APPLICATION NO:
F/2002/6217

LOCATION:
40 Seaford Road, Wokingham.

PROPOSAL:
Proposed single storey front & side extension to dwelling. Proposed erection of replacement conservatory and loft coversion with rear dormer extension.

SITE PLAN 1/250

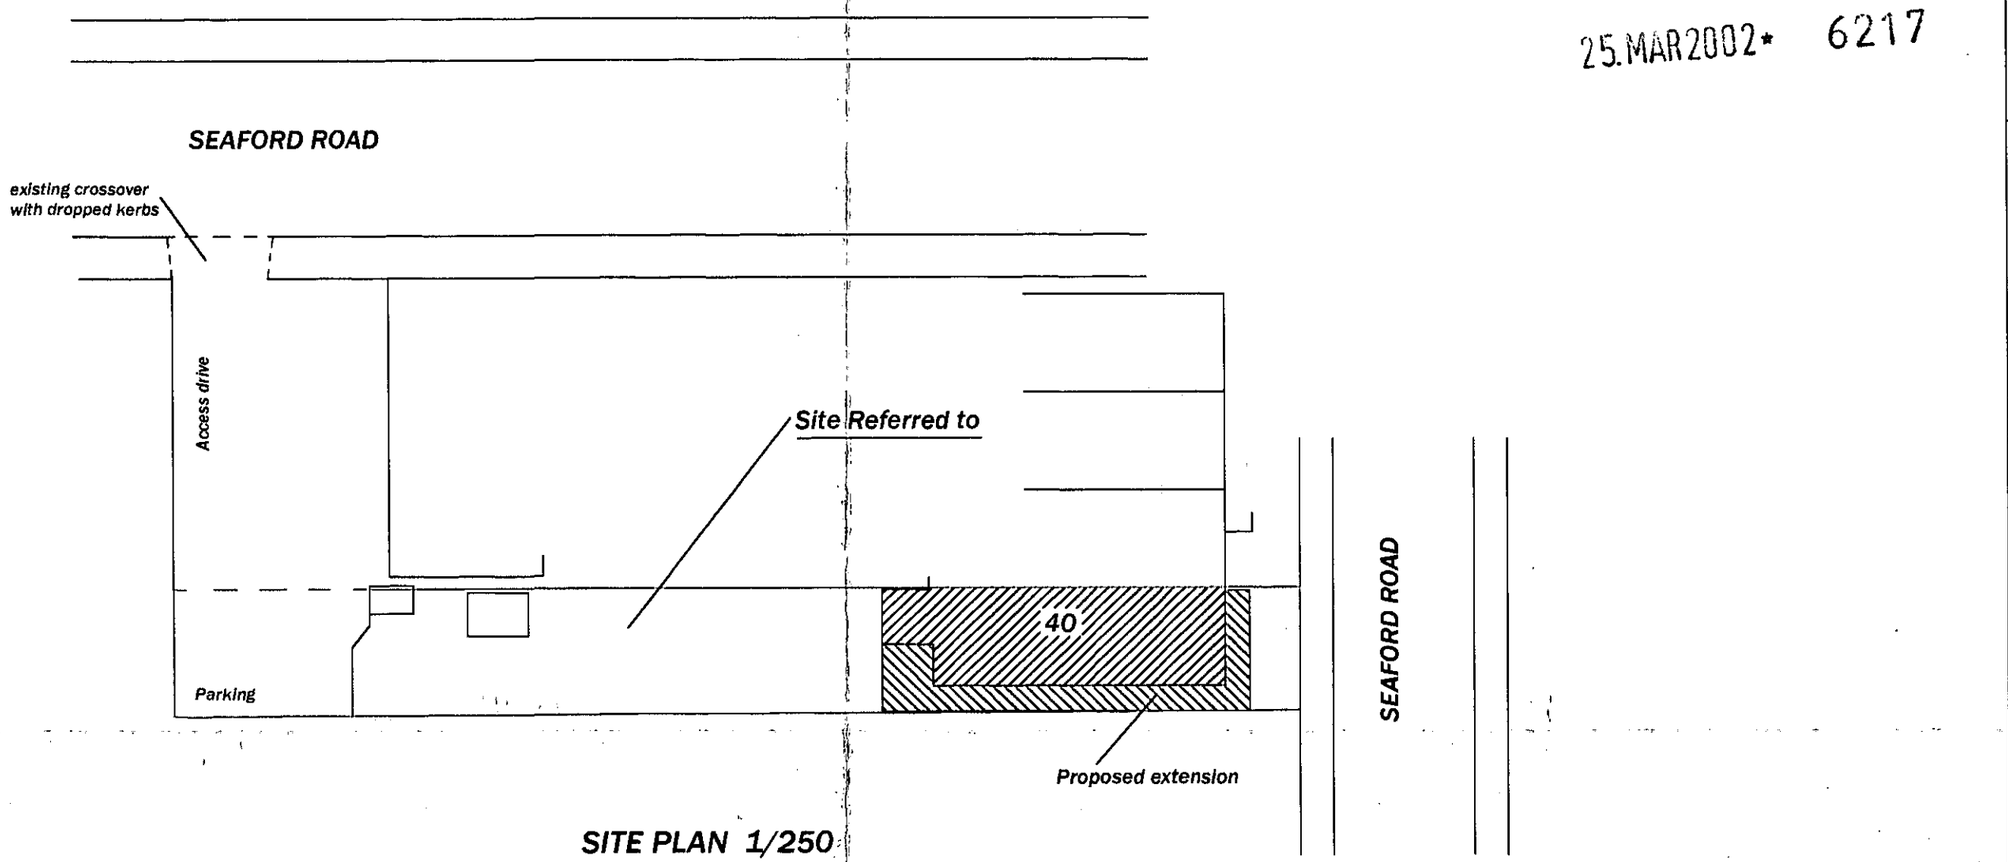
Please could Highways have an additional plan (at least 1:200 scale) showing the parking layout for 3 vehicles within the curtilage of the property. The outline of the spaces is to be marked on the plan accurately with minimum dimensions:

4.8m x 2.4m (standard space)
5.5m x 2.4m (in front of a garage)

The extent of the existing driveway must be clearly shown, along with details of any widening or alterations as a result of the proposal.

REAR ELEVATION

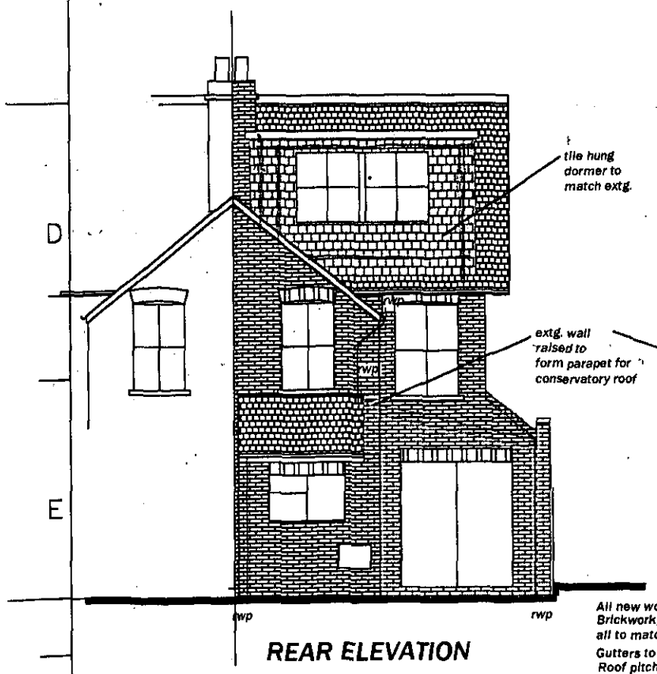
1. The flat roof over the rear attic level dormer window is visually unattractive, is visible from the street (from Seaford Road to the rear) and is not in keeping with the original house. There are no flat roof dormers in the immediate vicinity. The window is much wider than the existing windows. A pitched dormer and reduction in the width of the window would be preferable. The proposal is not in accordance with sections 2.5, 2.8 and 7.3 of doc. WU B2.

The flat roof dormer may also set a precedent for the adjoining terrace houses in this row and is in appearance not in keeping with the Edwardian character of the property.

8. The rear dormer to the roof extension, also looks to be too large in relation to the size of individual property and terrace as a whole. A smaller dormer set into the roof rather than on and replacing the roof would be far more suitable. Also a smaller dormer would allow a pitched roof and small gable rather than an expanse of flat roof which is totally out of character on a Victorian house.

SIDE ELEVATION

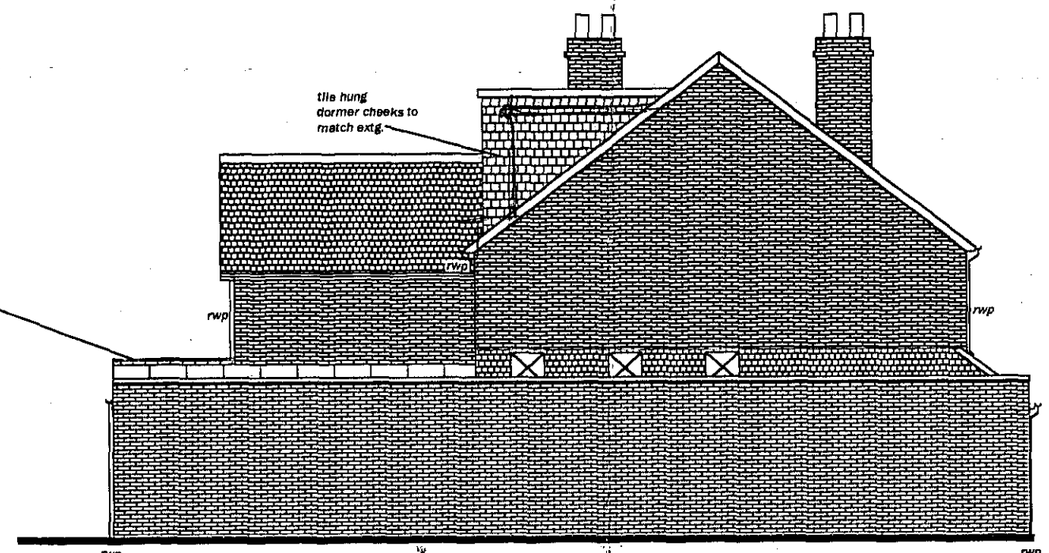
3. The velux windows on the side elevation are not in accordance with section 6.1 of doc. WU B2 (avoidance of windows on the flank elevation, which abuts our boundary).

6. On a safety issue, what measures are proposed to ensure that the parapet section of the brickwork wall adjacent to our boundary is restrained appropriately and has designed movement joints?

5. The parapet wall on the proposed side passageway again draws emphasis to the scale of the works by creating a further upright negative boundary to the house. The parapet wall adds extra height along the edge of the hipped roof to the extreme front edge of the house, further forward than the existing footprint adding to the impression of looming scale.

The proposed new first storey roof is un-resolved. By plan the roof is ended with a hip on my side where on elevation the roof is ended in a gable. It would be good to know the exact design put forward.

FRONT ELEVATION

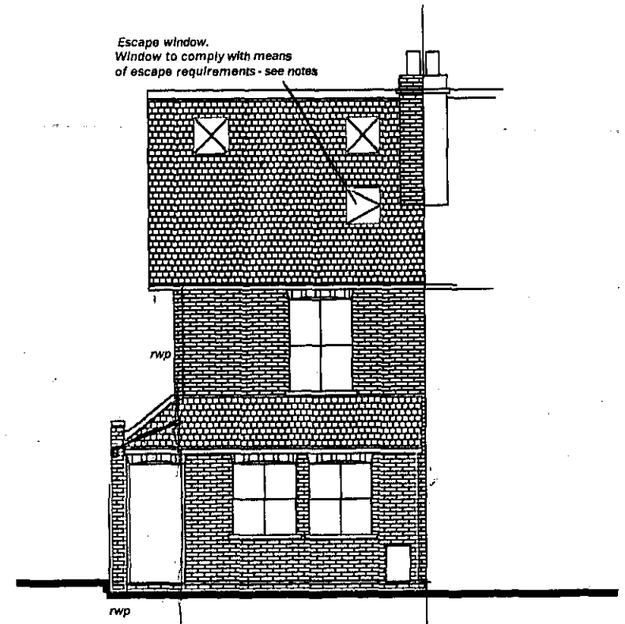
5. The front porch and extension will affect the street scene and is not in keeping with the remainder of the row of terraced houses. Although projecting the same as porches in the row the building extends over the front of the property reducing the

depth of the front garden and excluding our property from the street scene (which is already set back further than No. 40) (section 4.1 of doc. WU B2).

1. The front elevation of the proposed works has no semblance with the historic nature of the house(s). Within the terrace that number 40 is attached, and in the general vicinity there are no precedents for this style, or size of extension on this style or size of original, un-spoilt Victorian terrace house.

2. The proposed ground floor works to the front of the property totally disregard the rhythm of the existing front elevation of the terrace. Not only is the entire full width foot print moved forward, but also the inclusion of two ground floor windows of inappropriate size and possibly style go against the single front, ground floor window style currently enjoyed. The new fenestration of the elevation is not balanced, or centred externally on the existing elevation.

3. The proposed new entrance to the house emphasises further the inappropriate scale of the extension by making it full width, wider than the existing footprint. Again in relation to the terrace as a whole it acts as a destabilising agent.

7. The proposed works to the front of the house destroys the, largely unmolested street elevation of the terrace. The proposed creates an overall unbalanced elevation, particularly noticeable as the terrace is only 4 houses in size. If the terrace was of a larger scale, say 20 houses then the proposed works would not have such an overall detrimental effect on the other houses. But being only 4 houses in size, the terrace as a whole suffers by poor quality, unsympathetic design. The proposed full width (including side passageway) single storey extension is of a scale totally unsuitable to the size of house and size of the overall terrace.

As a side note I also doubt that the roof to the front will be build-able as proposed in the planning drawings. To maintain the pitch to match the existing roof pitch, there is possibly not enough height between the ground floor and first floor windows. This will necessitate either:

- A different pitch to existing which will look unbalanced as there is a considerable area of roof in the proposed works.
- Or the ground floor windows being reduced in size or set too low in relation to the other windows in the terrace street elevation to maintain the rhythm of the entire terrace street elevation.

GROUND FLOOR PLAN

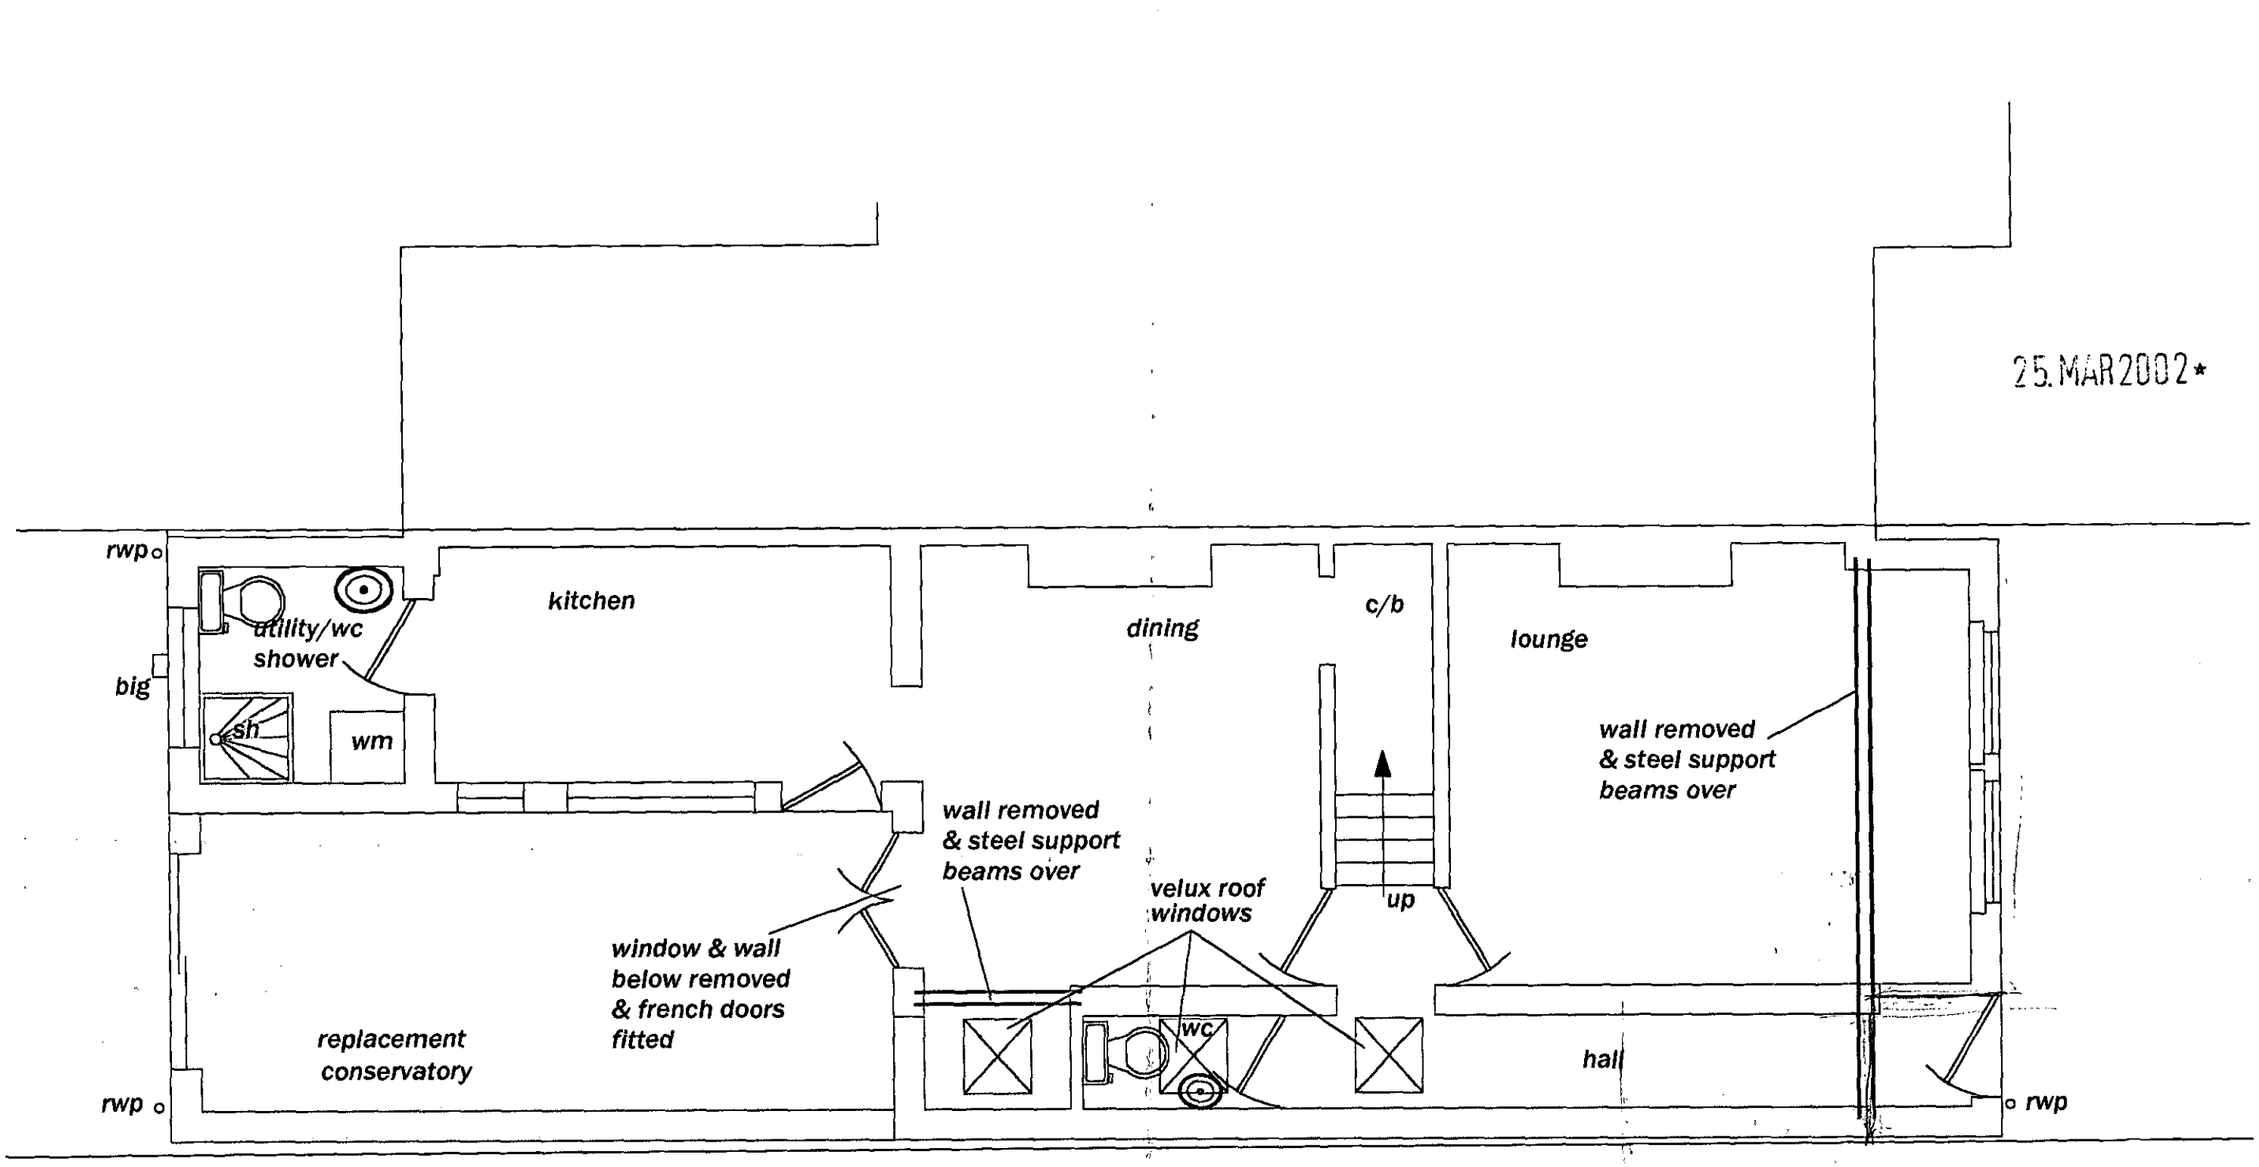
4. The WC will be close to the rear door of our property. This door is downwind of the WC for the prevailing southerly winds. What are the proposals to avoid smells and where will the soil and vent pipes, if applicable, be positioned?

4. To locate the new front door back mid way down the side passageway would allow the proposed new hall internally and take the door away from the living room without degrading the terrace as a whole.

6. The proposed front roof itself, viewed from the plan appears to be hipped. A hipped roof has no president elsewhere on this villa of terraces.
